INVITATION FOR BID (IFB) No. IFB-PAG-CIP-021-011

Design Build to Replace 3 EA. Metal Gate Booths with Extended Concrete Structure

ADDENDUM NO. 1

DRAWING NO. E24		SHEET NO. 242		TOTAL SHEETS 256	
JOSE L. GUERRERO COMMERCIAL PORT GUAN COMMERCIAL PORT IMPROVEMENT PROGRAM FACILITY EXPANSION		TERMINAL GATE DATA & POWER PLAN			
AMORIENT ENGINEERING		EA			
GUYTON CONSULTING					
REVISIONS		ISSUED		DATE	
DATE	BY	DESCRIPTION	DATE	DATE	DATE

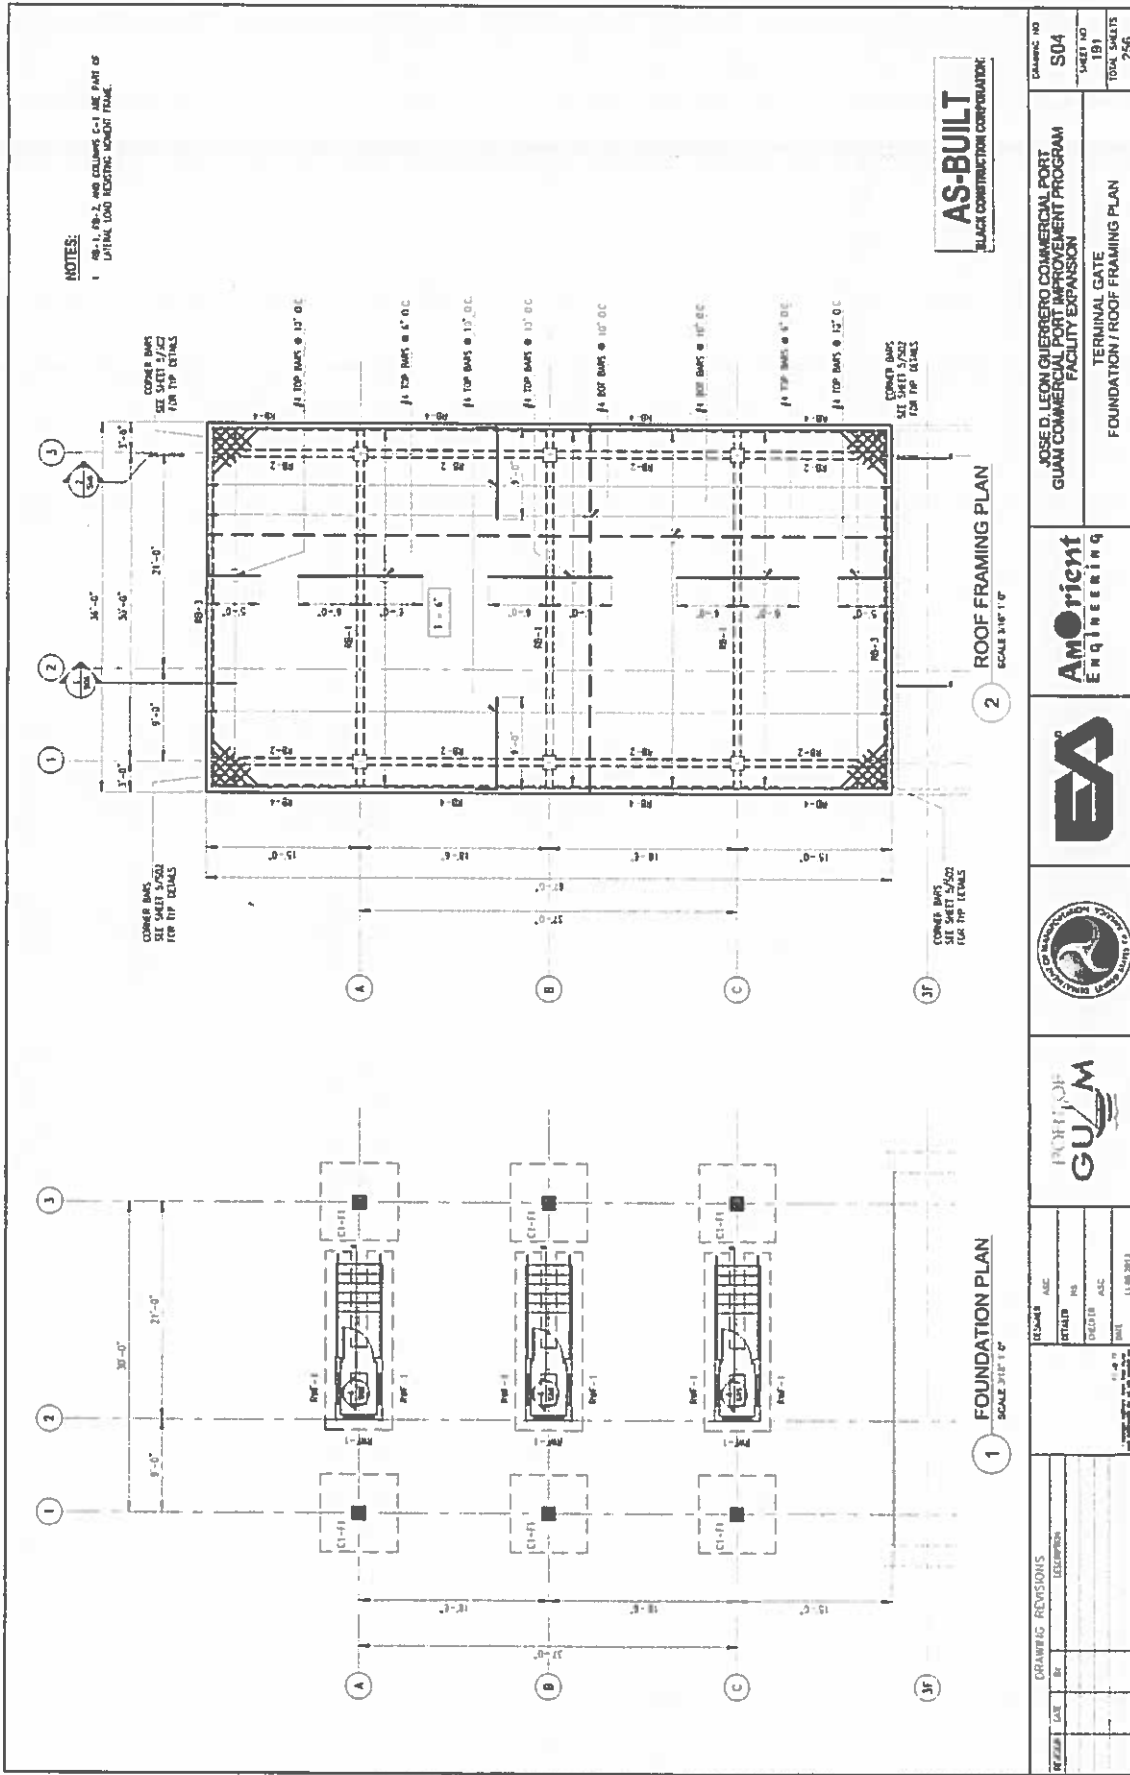
Question #2: Volume 5: Existing Floor Plan/Layout (Pages 83-84) Question 2 Please provide As-Built drawings (structural, electrical, communication, plumbing) of each existing metal gate booth.

- Response: See 3a. Door size (36"W X 80"H) (Clear Opening) plus marine grade aluminum framing.
- Question #8: Volume 5: Existing Floor Plan/Layout (Pages 83-84) Question 8 Please provide reinforcement details of the existing structure. Please provide As-Built drawings.

Response: See sheets DW04 , E24, S04, and S05 (Attachment 1)

- Response: See sheets DW04 , E24, S04, and S05 (Attachment 1)
- Question #9: Volume 5: Existing Floor Plan (Pages 83) Question 9 In reference to the highlighted plan below, are these reinforced concrete walls below the metal wall? Please provide details of these wall and the foundation.

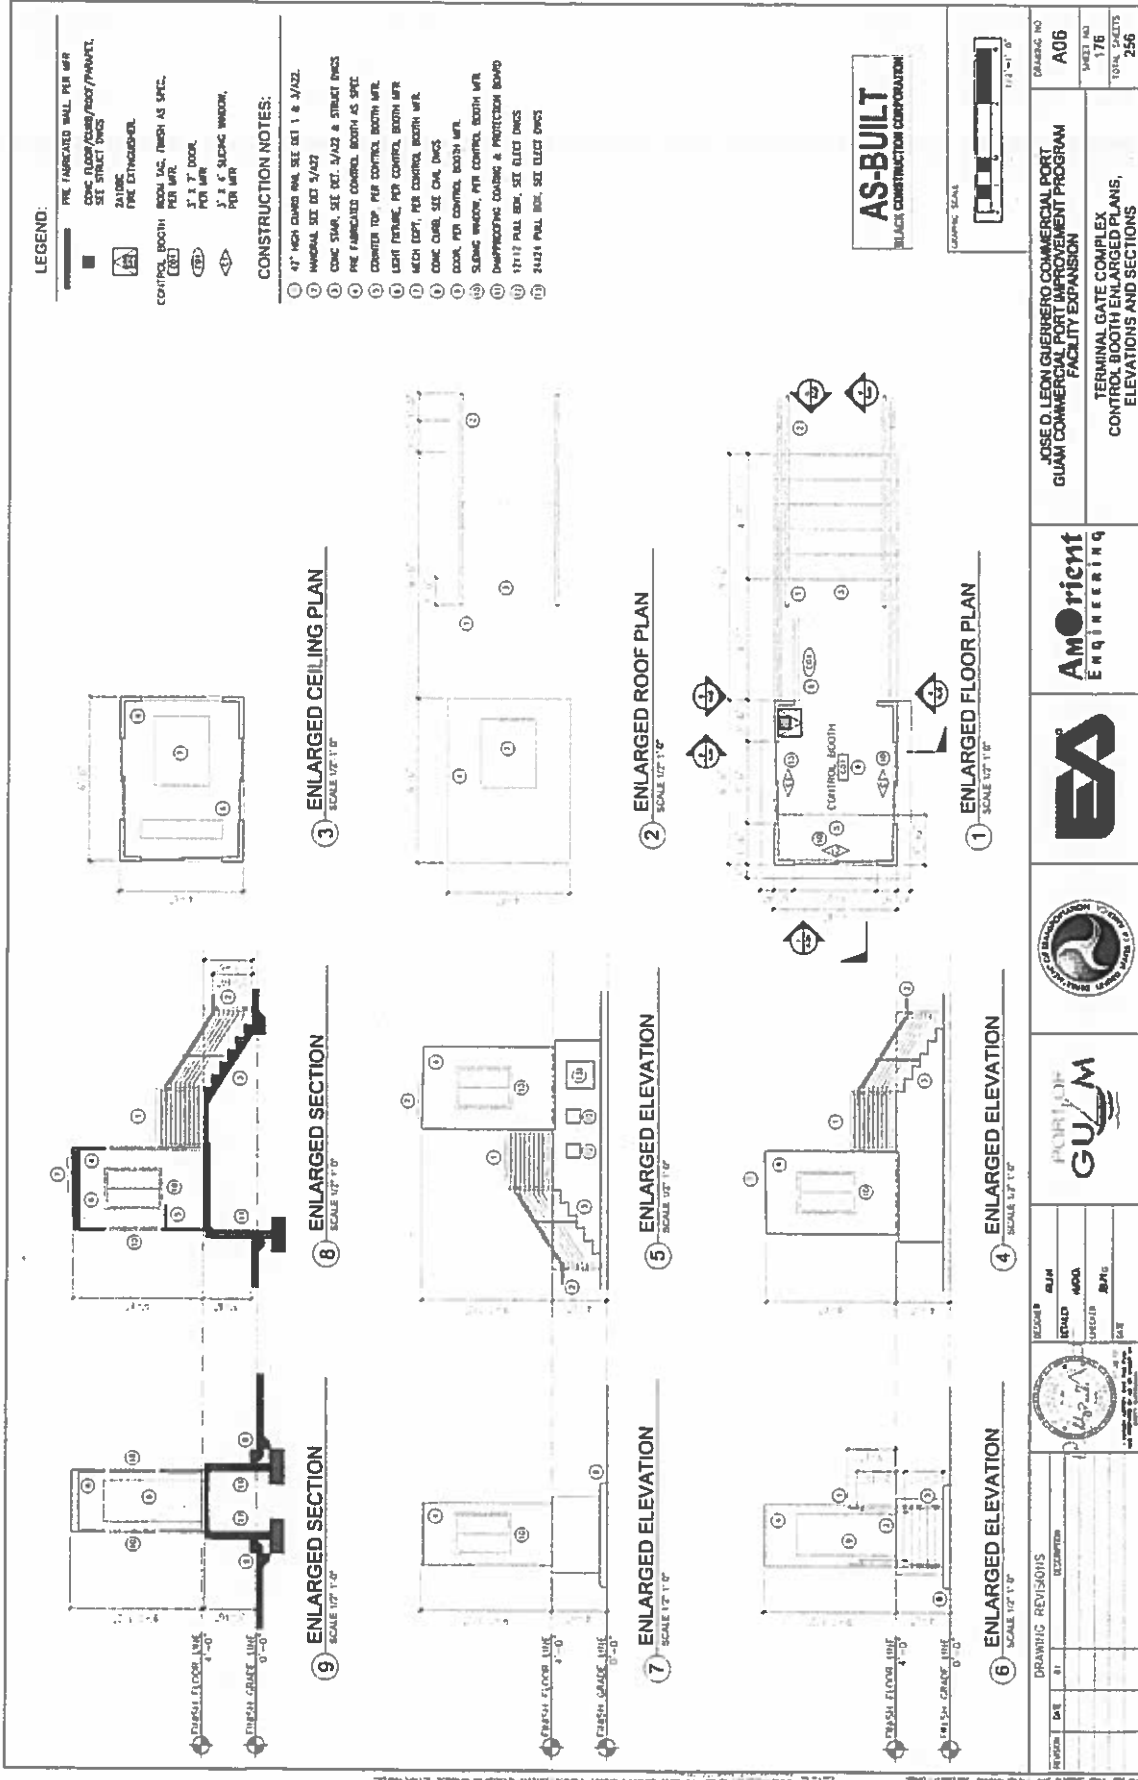
Question #3 Volume 5: Existing Floor Plan/Layout (Pages 83-84) Question 3 What are the existing underground utilities present within the vicinity of the project? Please provide As-Built drawings

Response: See Sheet A06 (Attachment#1). 2" diameter WL nearby main, ¾" diameter WL laterals, power/communication lines.
